MINOLTA α - 5	(2163-090)
MINOLTA α - 5 BLACK	(2163-091)
MINOLTA DYNAX 5	(2163-196)
MINOLTA DYNAX 5 DATE	(2163-296)
MINOLTA MAXXUM 5	(2163-395)
MINOLTA MAXXUM 5 DATE	(2163-495)
MINOLTA α -Sweet II BLACK	(2163-690)
MINOLTA α -Sweet II	(2163-695)

PARTS MODIFICATION LIST

2163-761

2163-854

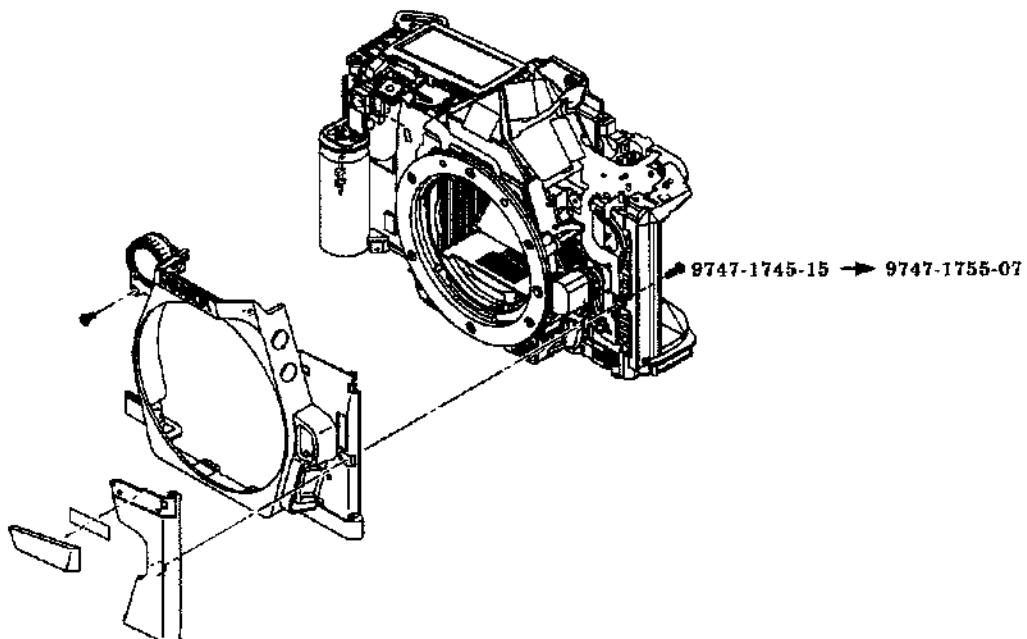
REASON 変更理由	ネジの緩み防止 To affix the front side cover firmly.	COMMON MODEL 共通機種	2163 Series
Previous	9747-1745-15	—	—
Previous	—	—	9747-1755-07

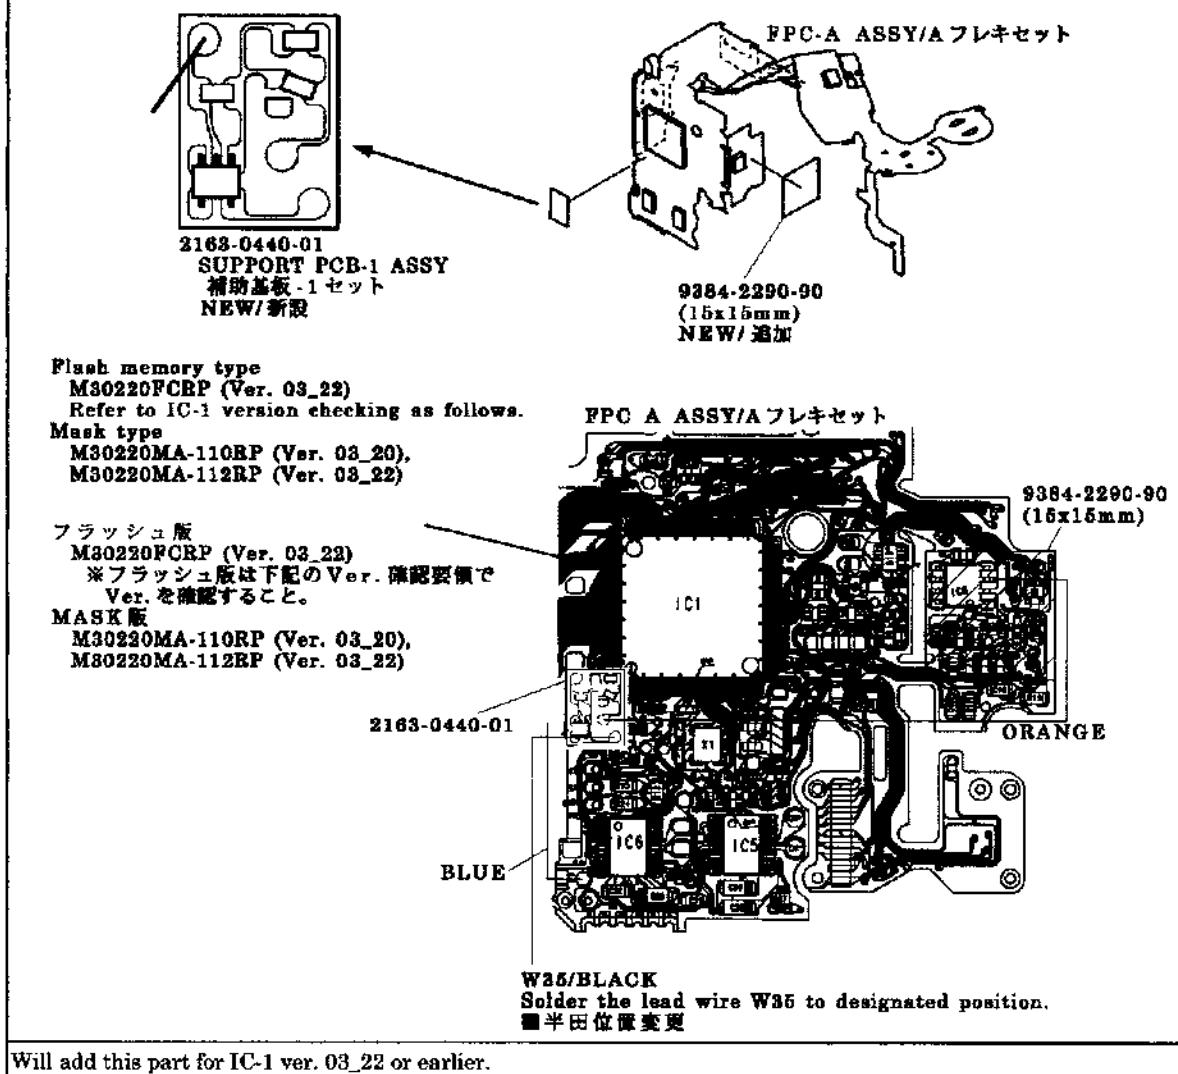
REASON 変更理由	電池装着でEEPROMデータ変化に対する改善 To prevent writing in the wrong data to EEPROM while attaching batteries.			COMMON MODEL 共通機種	2163-090, -296, -495, -695
Previous	_____	_____	_____	2163-0440-01	New
Previous	_____	_____	_____	(9391-0807-06)	New
Previous	_____	_____	_____	9391-0807-03	New
Previous	_____	_____	_____	9384-2290-90	New

Will add this part for IC-1 ver. 03_22 or earlier.

While all displays on is selected, pressing the spot-AE lock button shows the IC-1 version in the data panel.
(Refer to pg.77 of Repair Guide.)

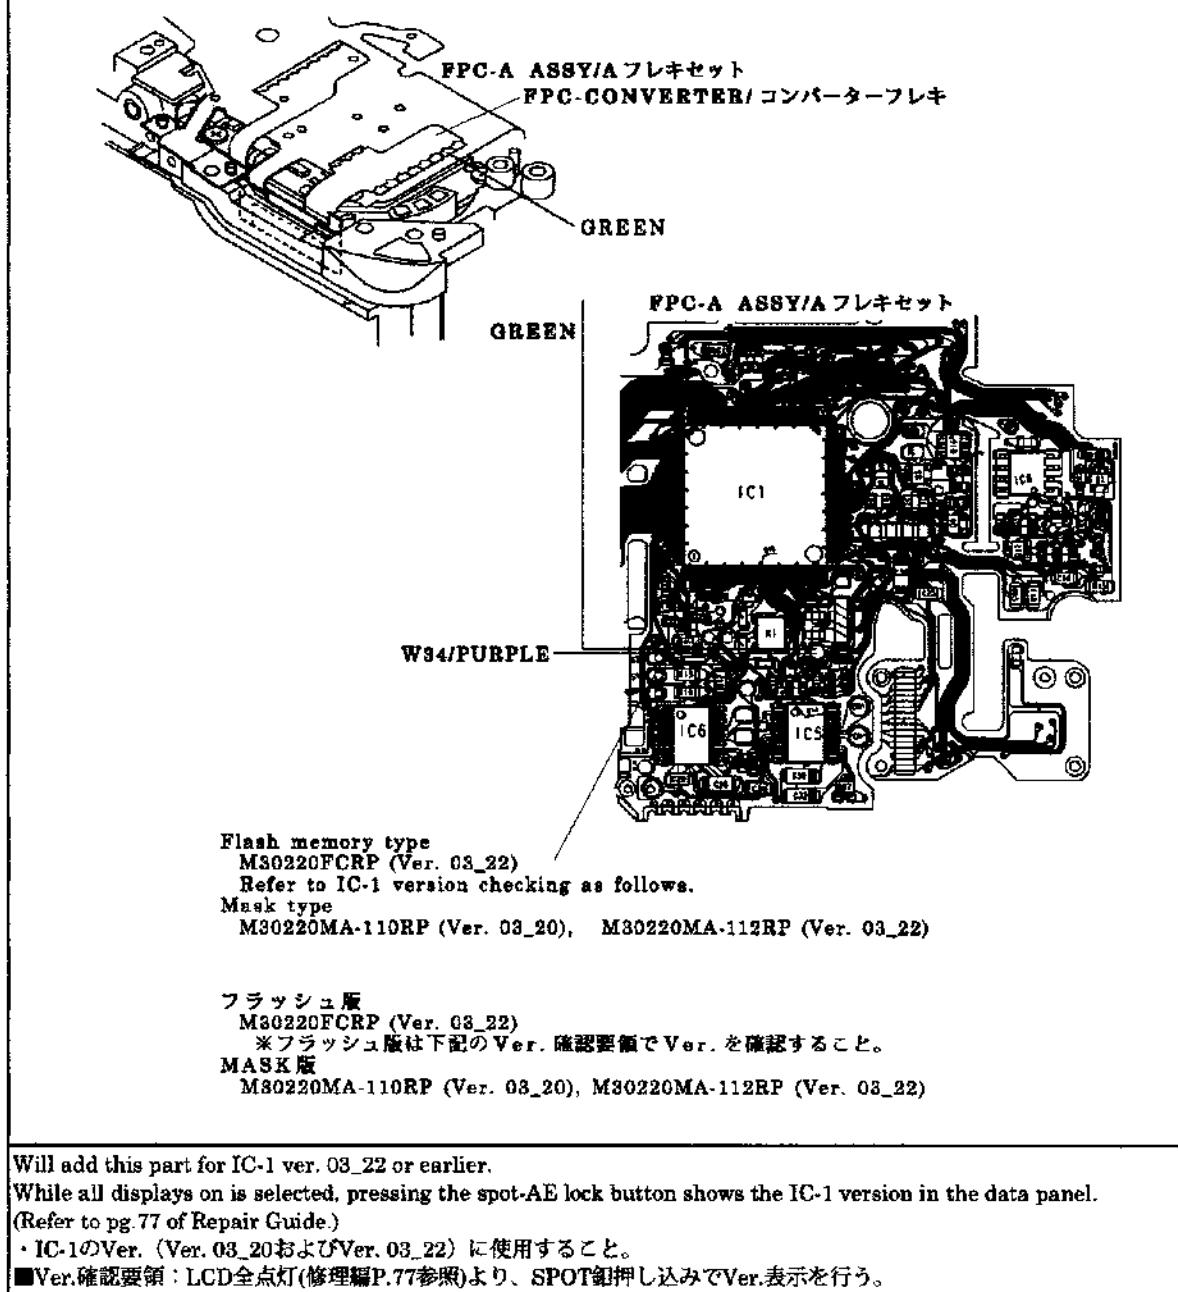
REASON 変更理由	電池装着でEEPROMデータ変化に対する改善 To prevent writing in the wrong data to EEPROM while attaching batteries.	COMMON MODEL 共通機種	2163-196, -395
Previous	—	—	9391-0807-05 New

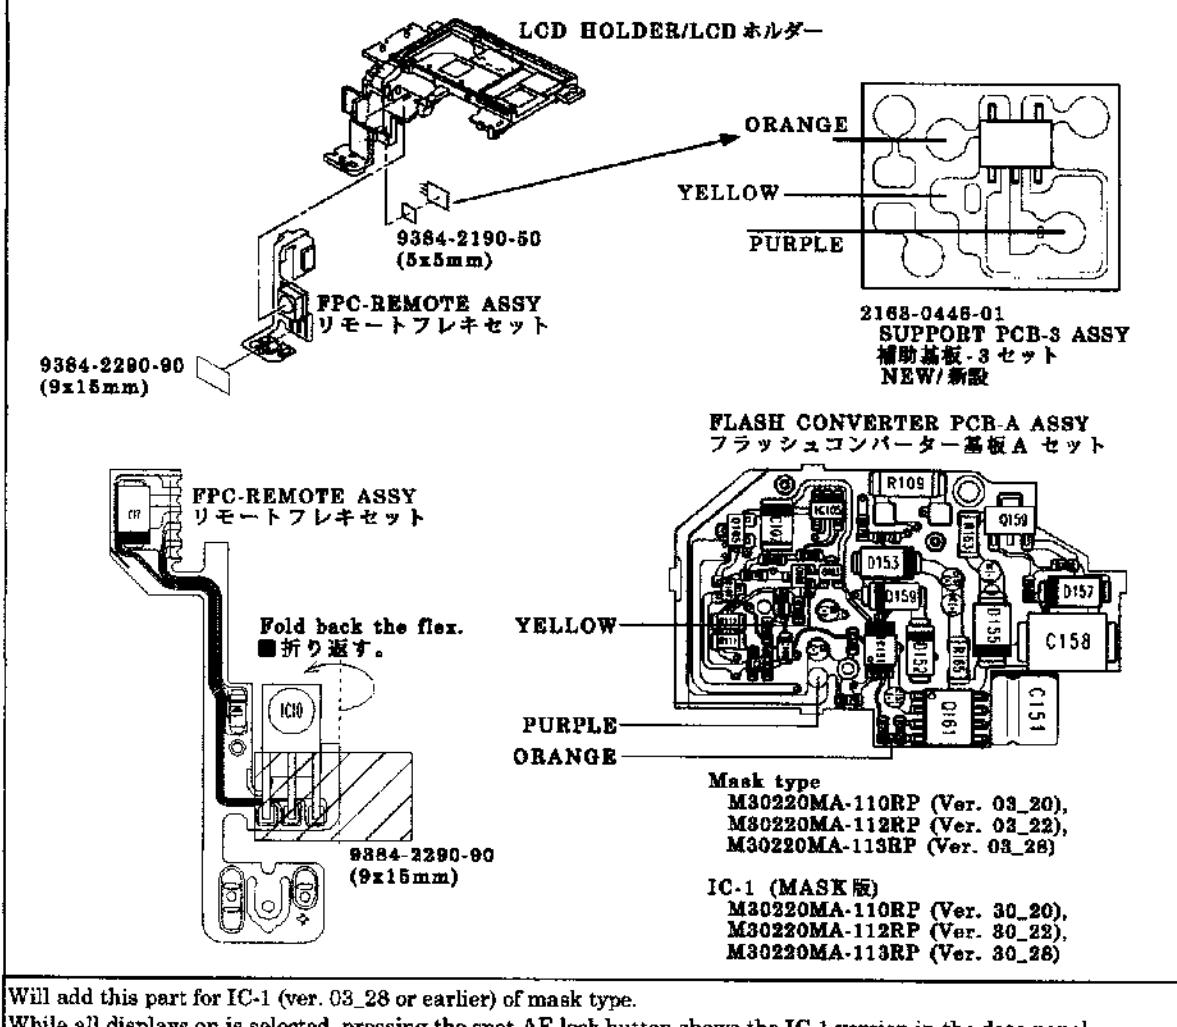
REASON 変更理由	COMMON MODEL 共通機種			2163 Series
To prevent firing the built-in flash with minimum output while attaching batteries.				
Previous	—	—	—	2163-0446-01 New
Previous	—	—	—	(9391-D807-03) New
Previous	—	—	—	(9391-D807-04) New
Previous	—	—	—	(9391-D807-07) New
Previous	—	—	—	9384-2190-50 New
Previous	—	—	—	9384-2290-90 New

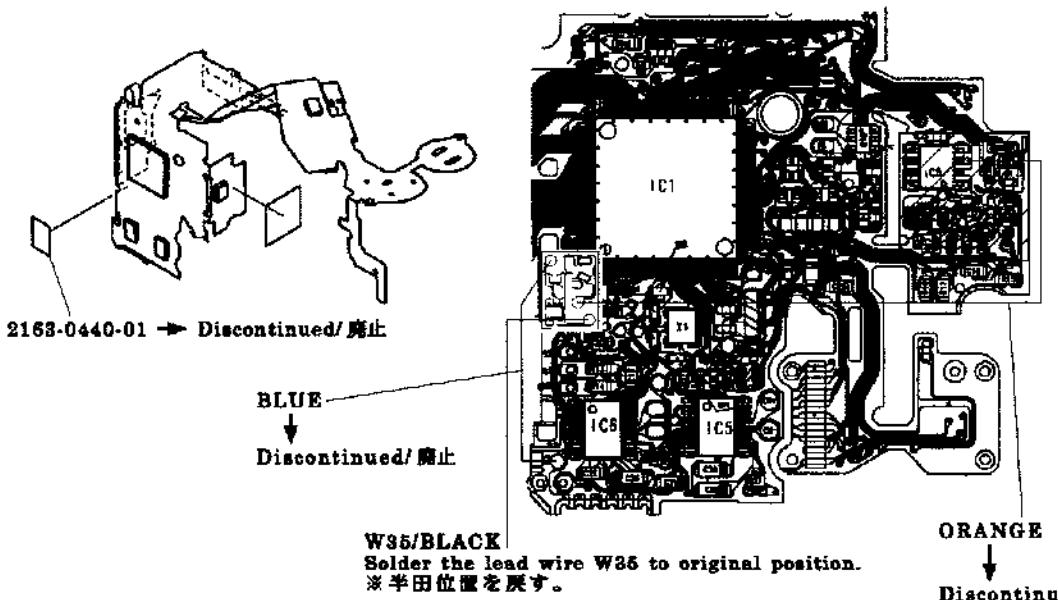
REASON 変更理由	ROMバージョンアップ ROM version update	COMMON MODEL 共通機種	2163-090, -296, -495, -695
Previous	2163-0462-01	→×	×← 2163-0462-02 New

Previous	2163-0440-01	→×	×←	—	New
Previous	(9391-0807-06)	→×	×←	—	New
Previous	9391-0807-03	→×	×←	—	New

While all displays on is selected, pressing the spot-AE lock button shows the IC-1 version in the data panel.
 (Refer to pg.77 of Repair Guide.)

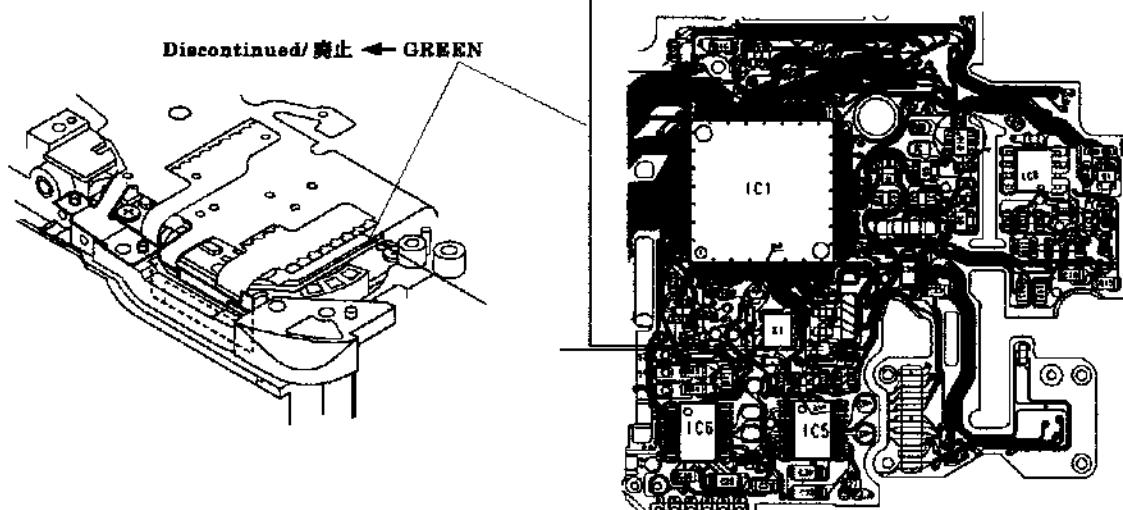
REASON 変更理由	ROMバージョンアップ ROM version update	COMMON MODEL 共通機種	2163-196, -395
Previous	2163-0408-01	→ X	X ← 2163-0408-02 New

Previous	9391-0807-05	→ X	X ←	—	New
----------	--------------	-----	-----	---	-----

While all displays on is selected, pressing the spot-AE lock button shows the IC-1 version in the data panel.
 (Refer to pg.77 of Repair Guide.)

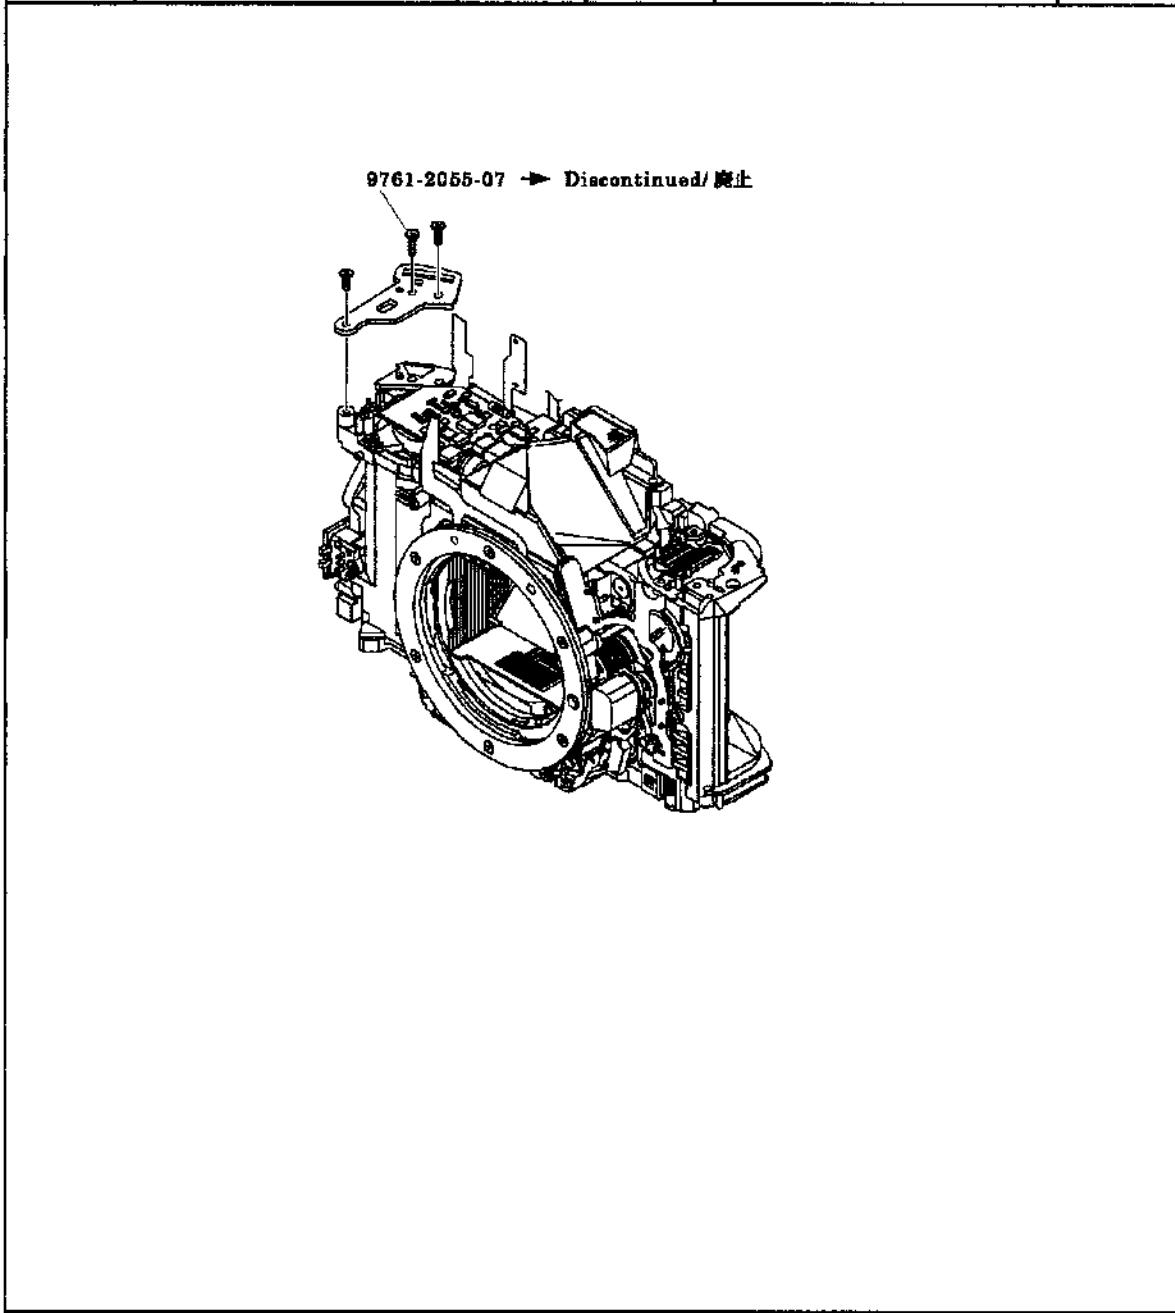
REASON 変更理由	コストダウン To cut cost	COMMON MODEL 共通機種	2163 Series
Previous	9761-2055-07	—	—

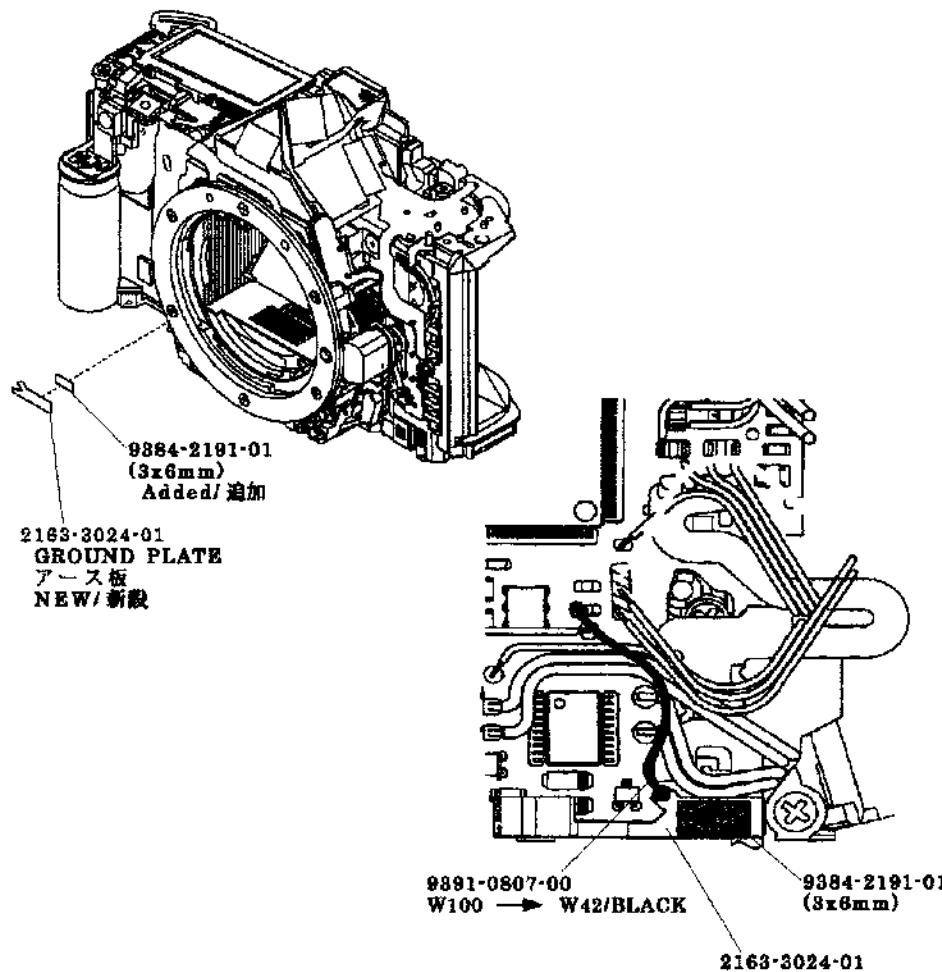
REASON 変更理由	静電気対策 To prevent static electricity	COMMON MODEL 共通機種	2163 Series
Previous	—	—	2163-3024-01 New
Previous	—	—	9384-2191-01 New
Previous	9391-0807-00	—	9391-0807-00 New

Remove the lead wire W100 between Body and WINDING BASEPLATE ASSY, and solder it to the illustrated position as lead wire W42.
W100を廃止し、W42とし図のように半田付けする。

2163-0700-01
MIRROR BOX ASSY (PANORAMA)
 ミラー ボックス セット (パノラマ)
 NEW / 新設

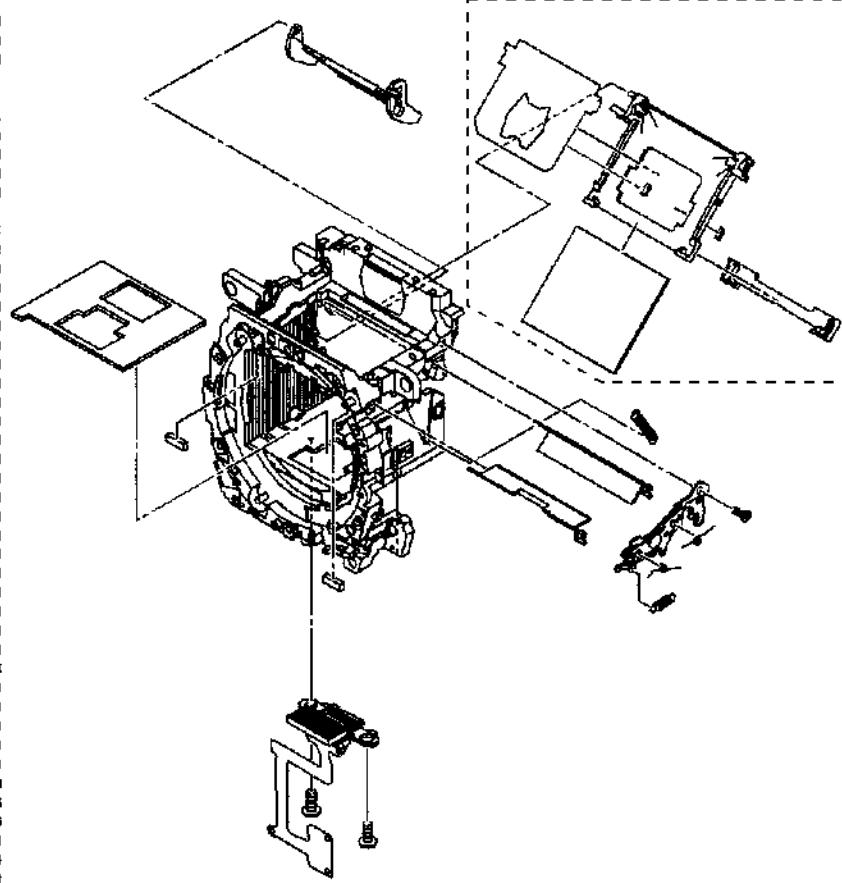
REASON 変更理由	サービス供給部品として設定する To supply as a spare part for PANORAMA MODEL.	COMMON MODEL 共通機種	2163-090, -091, -690, -695
Previous	—	—	2163-0700-01 New

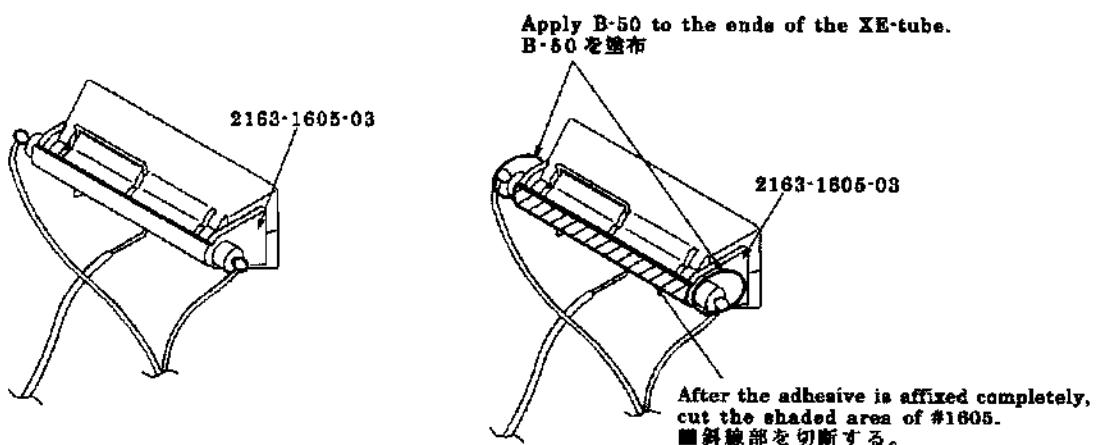
REASON 変更理由	XEチューブのスパーク防止 To prevent the xe-tube sparking.	COMMON MODEL 共通機種	2163 Series
Previous	2089-1605-01	—	—
Previous	—	—	2163-1605-03

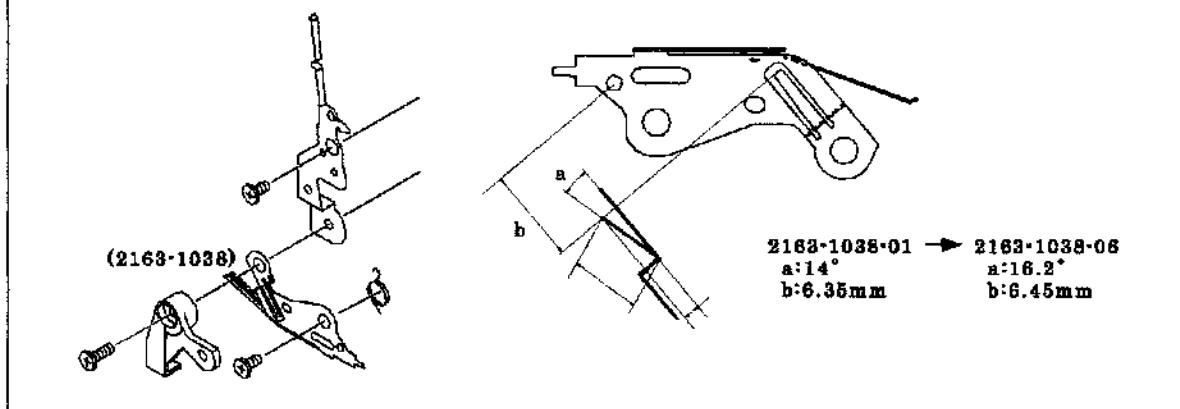
REASON 変更理由	セーフティロック切替えカムへの乗り上げ防止 To improve the safety lock changeover cam operation	COMMON MODEL 共通機種	2163 Series
Previous	(2163-1038-01)	→○ X←	(2163-1038-06) New

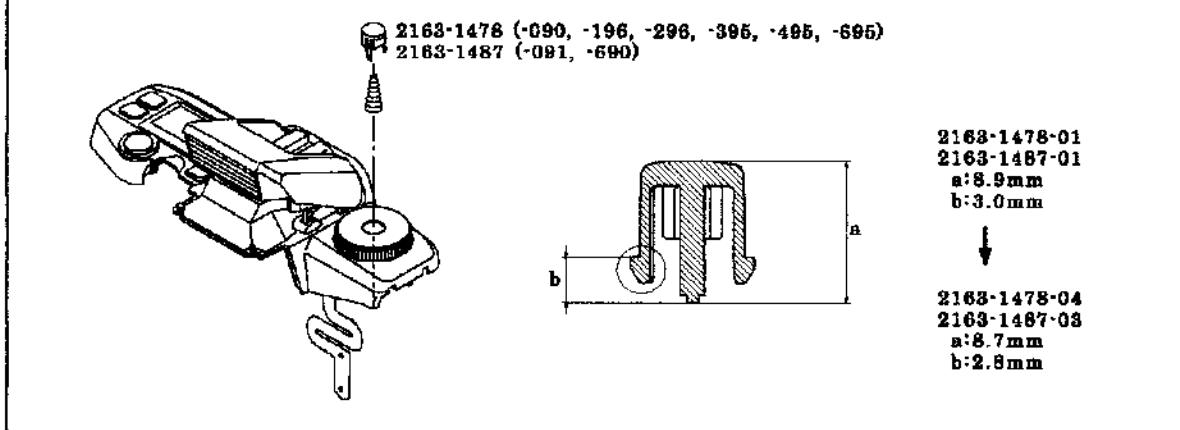
REASON 変更理由	ファンクションダイヤル操作でのファンクション鎖ON防止 To protect SFUNC ON by turning the function dial	COMMON MODEL 共通機種	2163 Series
Previous	2163-1478-01	→○ X←	2163-1478-04 New
Previous	2163-1487-01	→○ X←	2163-1487-03 New
